**Amendments To The Drawings:**

**REMARKS/ARGUMENTS**

Fig. 1

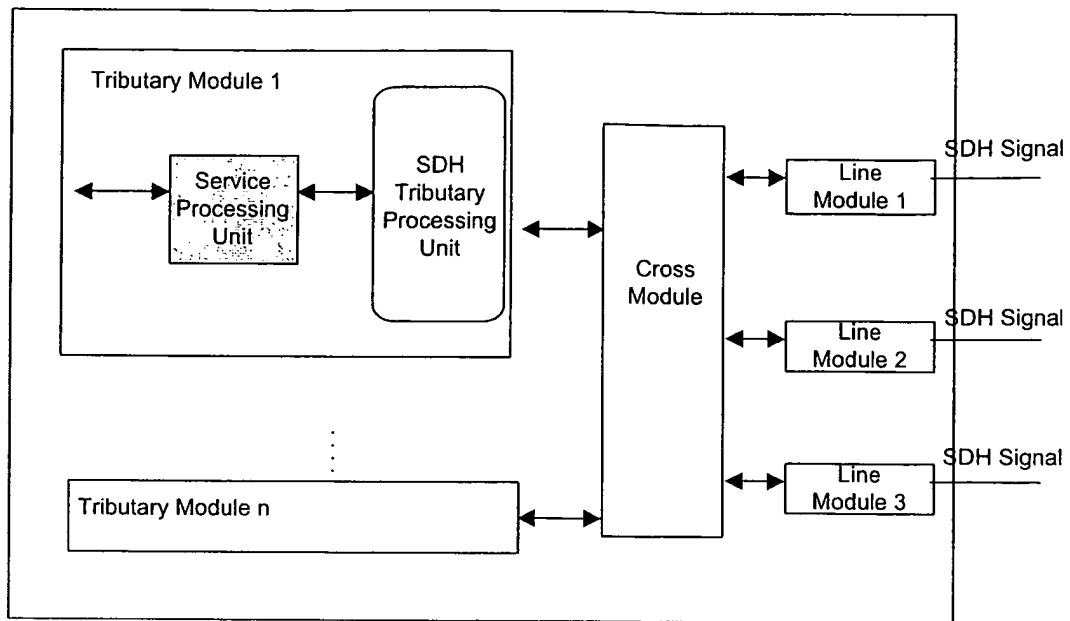
**In the office action (page 2), the drawings stand under 37 CFR 1.121(d) as they should be designated by a legend such as --Prior Art--.**

In response the Applicant has subsequently amended FIGs. 1-2 to include the legend --Prior Art-- to remove the basis for this objection. Therefore, the examiner is respectfully requested to withdraw this objection to the drawings.
